RE: Lot 31 Block 6 Unit 18, S.A.D. 228

6543 Pato Rd. NW

Grading and Drainage Plan

Engineers Stamp Date 6-19-17 (D10D003M31)

> > AYALA — GRADING & DRAINAGE PLAN

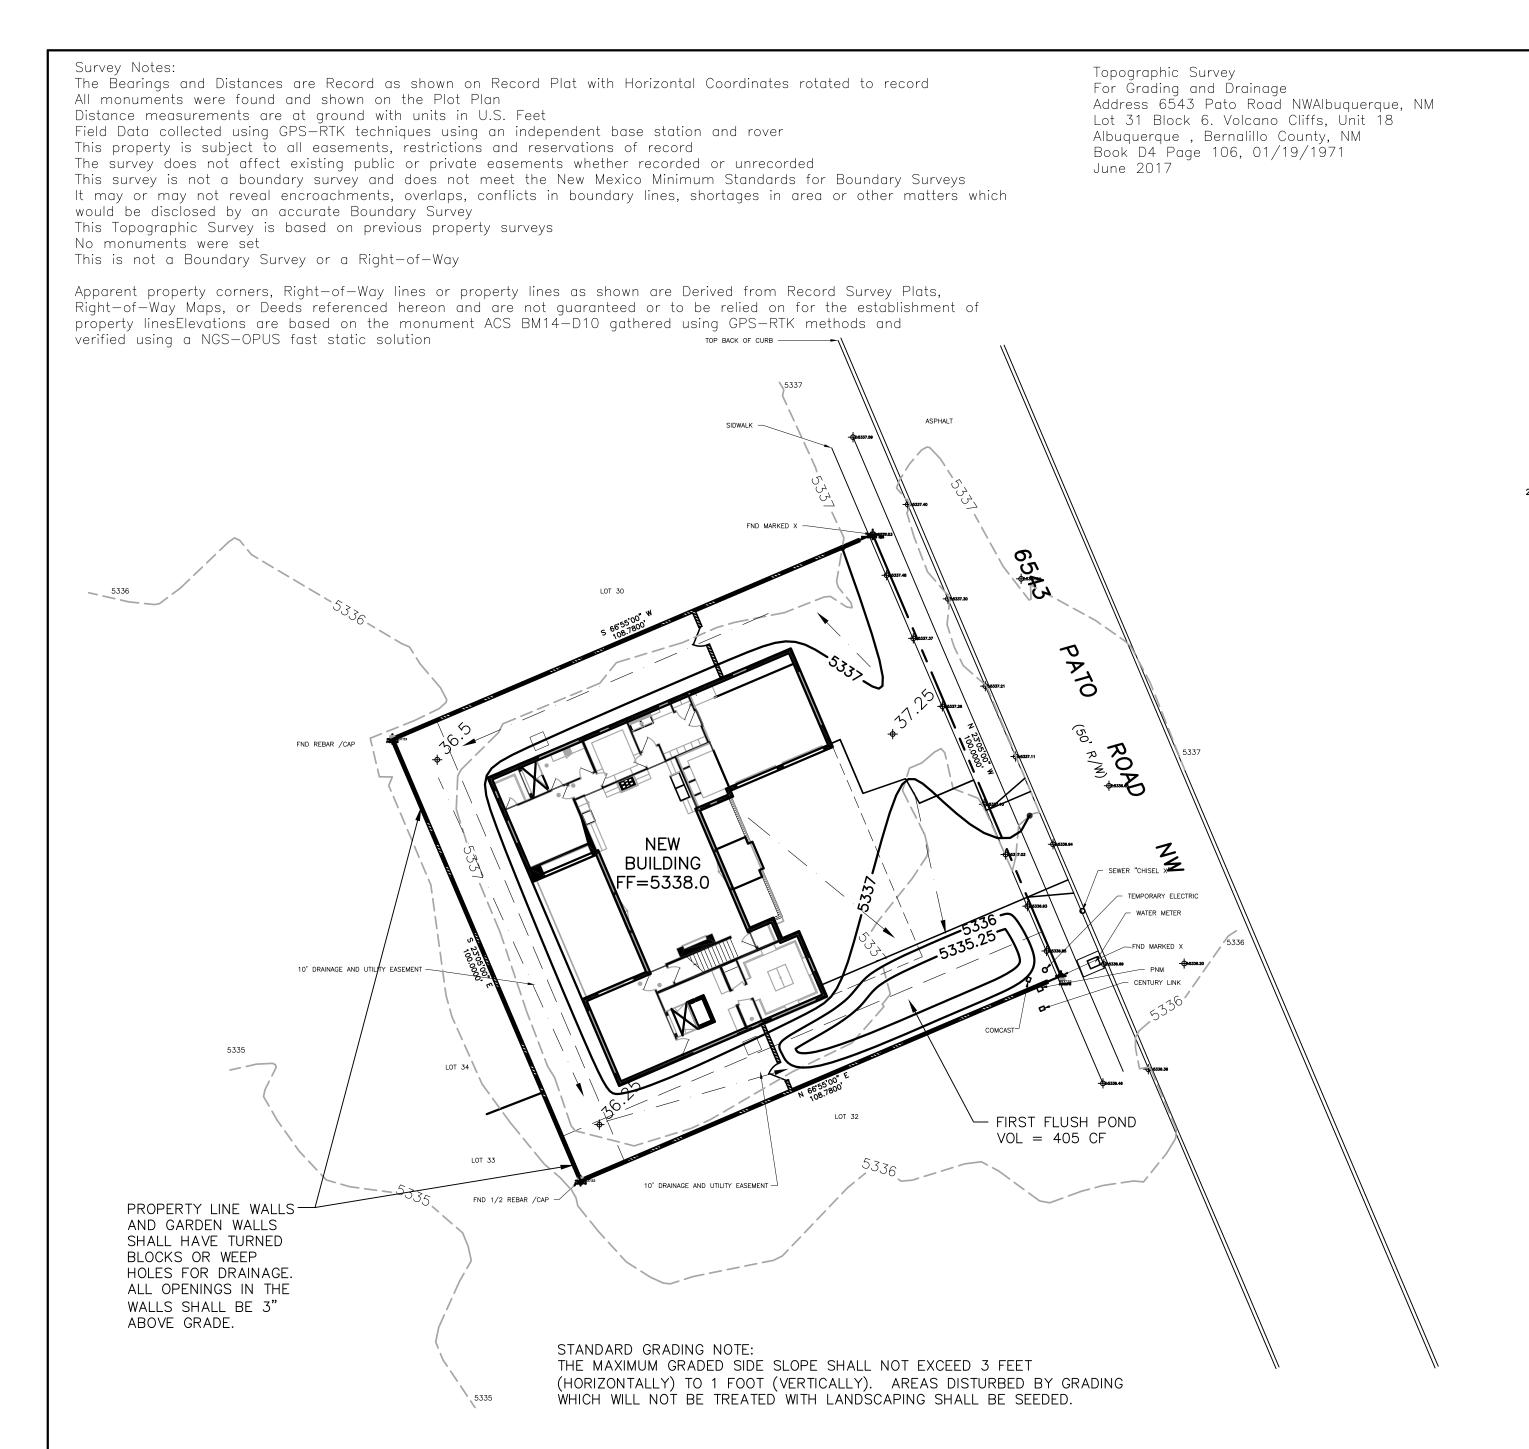
Provide the calculations for the openings in the North and South rear yard walls for flows heading North to South, as well as the southwest corner rear yard wall for flows heading from east to west.
